SYDNEY CENTRAL PLANNING PANEL

| SCPP No | 2017SCL019 |
| DA Number | 2017/1022 |
| Proposed Development | Integrated Development Application for the construction of a residential flat building consisting of one level of basement car parking, a podium and two towers, 1 x 6 storeys and 1 x 8 storeys. The development will accommodate 167 apartments and a child care centre. |

Figure 17. Stage 1 Building Separation Dwg No. A007

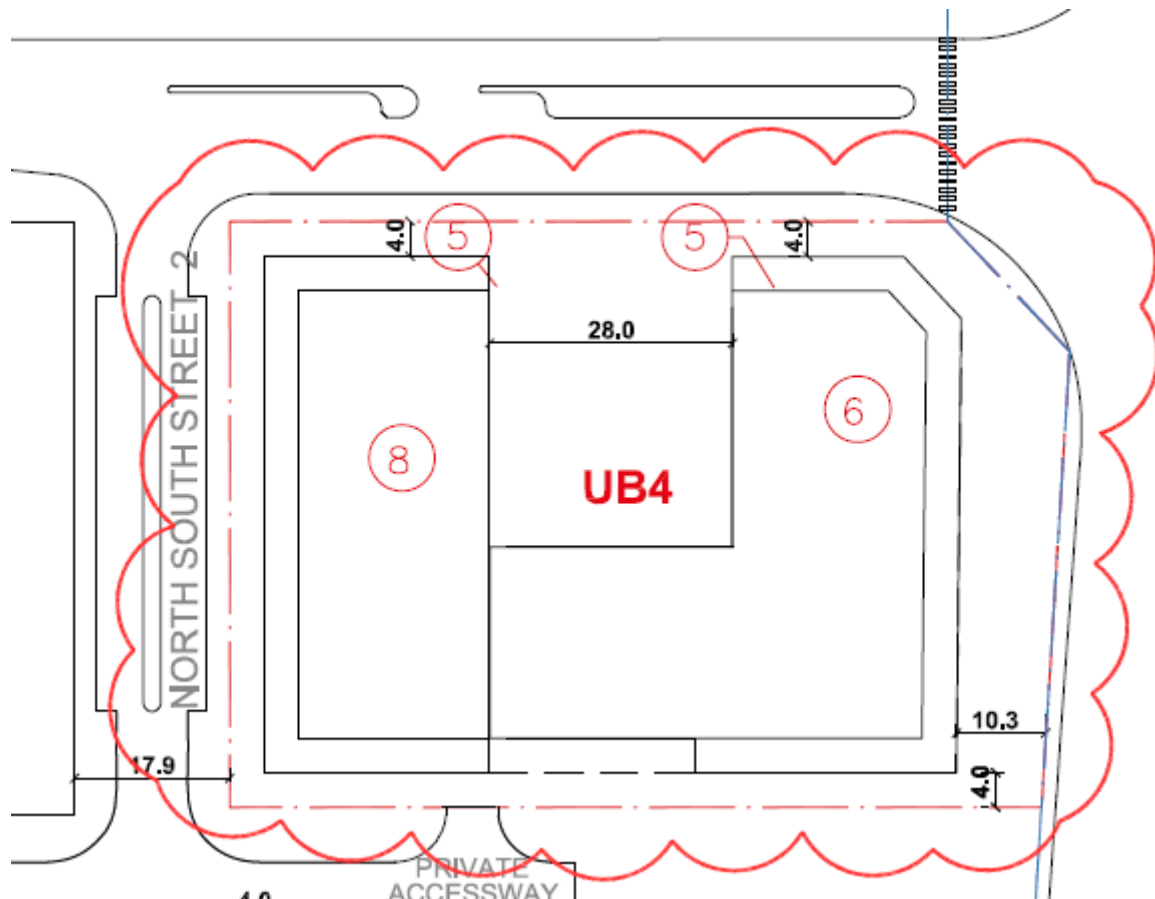
The Stage 1 consent approved a separation distance of 28 metres between the podium for Ground Level to Level 5. The proposed development is generally consistent with the approved building separation distances. However, the proposal does not comply with the building separation between the 6 and 8 storey towers for ground floor to Level 4. The development proposes a separation of 27 metres. The non-compliance is a variance of 1 metre and is contained to a small portion of the building between a bedroom within A-111 and B-106 (and each respective level above in both towers) as well as the balconies between A-111 and A-112 and B-106 and B-105.

Additionally, the development proposes internal corners in which units are located in close proximity to one another. In the below figures which is a privacy treatment plan which the applicant has provided, the applicant has proposed vertical privacy screening to be installed on the north facing balconies to mitigate any overlooking within the units. Also, the windows directly fronting a unit have been appropriately positioned so that they are opposite a blank

wall. Any directly overlooking from the east facing to the west facing units and vice versa is acceptable as 27m-28m is an appropriate distance. It does comply with the ADG minimum building separation distances between habitable and habitable areas of 12 metres.

Figure 20. Proposed areas of protrusion within the setback zone

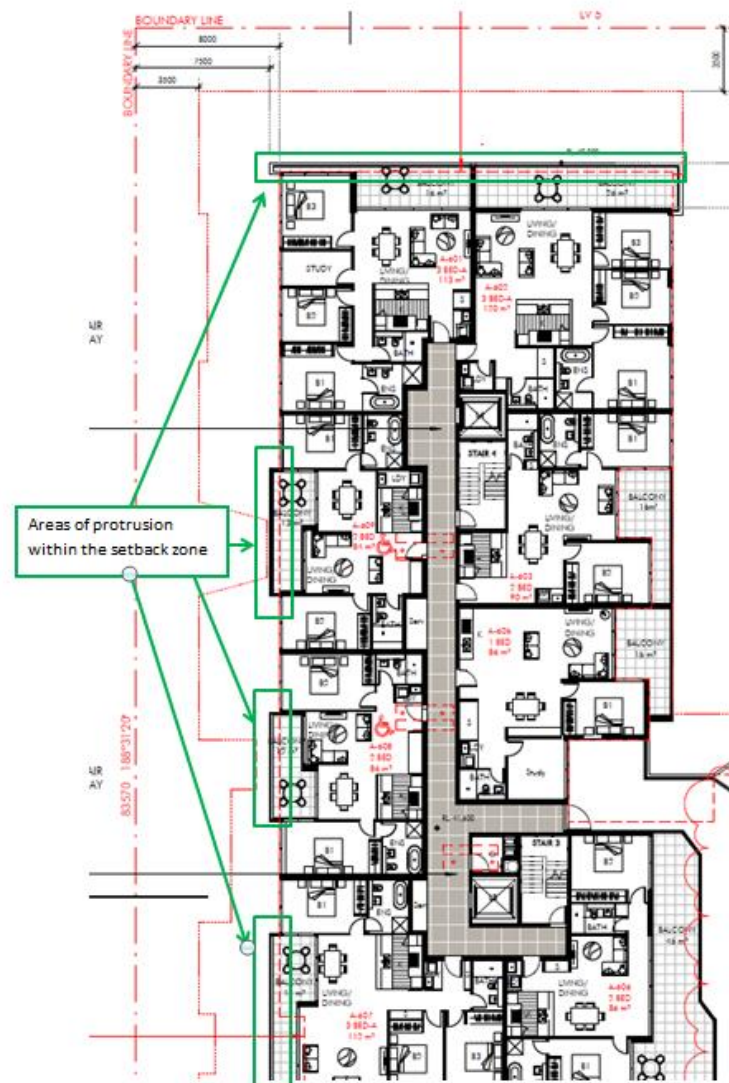
In regards to Condition No. 23, Levels 5 to 7 are located on top of the podium and have been setback away from the building edge by 3.5 metres and greater. This non-compliance is limited to the balconies and a small portion of the habitable areas on Levels 6 and 7 (along the southern side). This does not comply with the minimum 4 metre setback requirement as stated within Condition No. 23. However, Condition No. 24 and 25, which is outlined below, does allow a 500mm protrusion zone on each façade. As the non-compliance allows for greater articulation to the façade (as demonstrated in Figure 20) and the non-compliance face either the western side to Central Park and the southern and northern side which is separated by streets and open space, the impact is not considered significant on the surrounding neighbours. Therefore, the setback is acceptable.

Figure 21. Building Articulation Plan

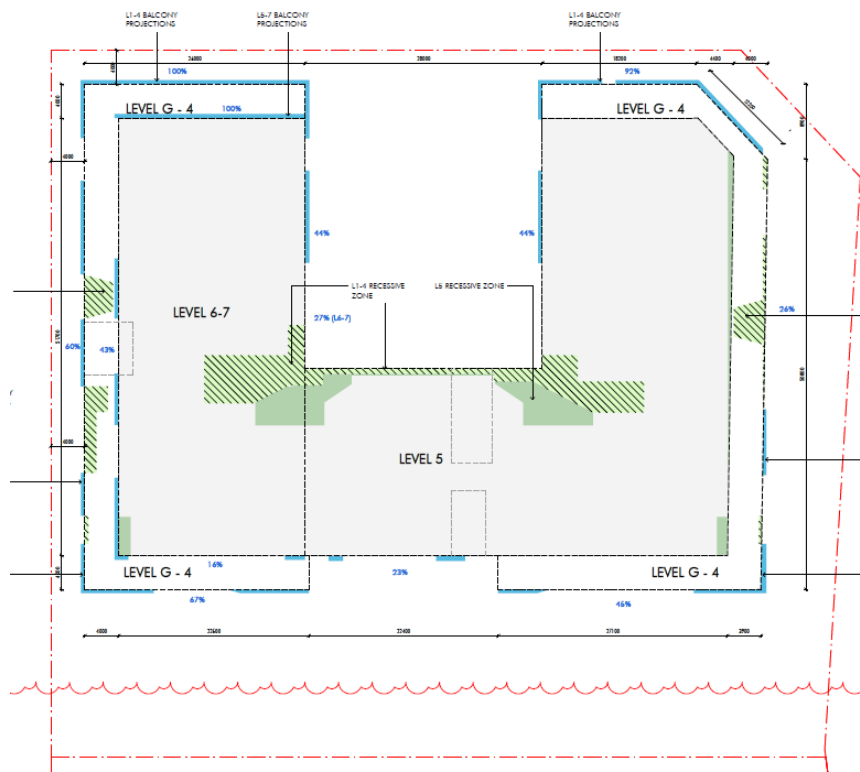
The applicant has provided a building articulation plan (Figure 21) to demonstrate the areas of protrusion and recessive zones. The areas highlighted in blue are the protrusion zones and the areas highlighted in green are the proposed recessive zones for both the towers and the podium. As demonstrated in the plan, the areas of recession are greater in area than the areas of protrusion. It is clear that internal to the development, there is greater articulation to allow for better flexibility to the development. Additionally, the extension of balconies over the setback envelope, which is the main reason for the protrusion, allows for greater articulation on the northern, western and eastern side.

The proposal meets the objective of the conditions to provide articulation and the meaning of 'façade' in the condition could be interpreted as meaning the combination of the 4 faces of each tower. Using this meaning for 'façade' the proposal achieve the maximum 50% articulation outside the approved envelope for the entire site. This is acceptable in this case.

Figure 22. Northern Elevation Comparison between proposal and winning design

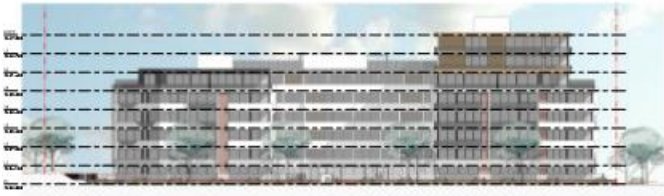
- Vertical timber material within the indent along the western and eastern elevations is missing. This is to be restored as per winning design scheme as it provides a visually interesting element that breaks up these facades.
- Ground floor fences to courtyards are facebrick. The design competition had a combination of rendered brick and face brick. This is to be restored.
- North-south and east-west through site link has been deleted from the winning design scheme. This is not supported as it provided a connection from the main boulevard to the open space between UB4 and UB5E. This is to be restored.

Amended plans were provided on 26 July 2017 and 3 August 2017 demonstrating that the amended proposal has reverted back to the winning design. The original winning scheme had located the childcare centre on the north-eastern corner of the site. The change in location of the childcare centre was considered and Council was not opposed to the new location which is now on the south-eastern side of the site. Further to the modifications that were carried out on the proposal to revert the scheme back to the winning design, the Panel recommended that the proposal be presented to the Design Review Panel. The proposal was presented to Design Review Panel on 6 July 2017 in which the Panel members had no issues with the design of the proposal and were overall supportive of the development.
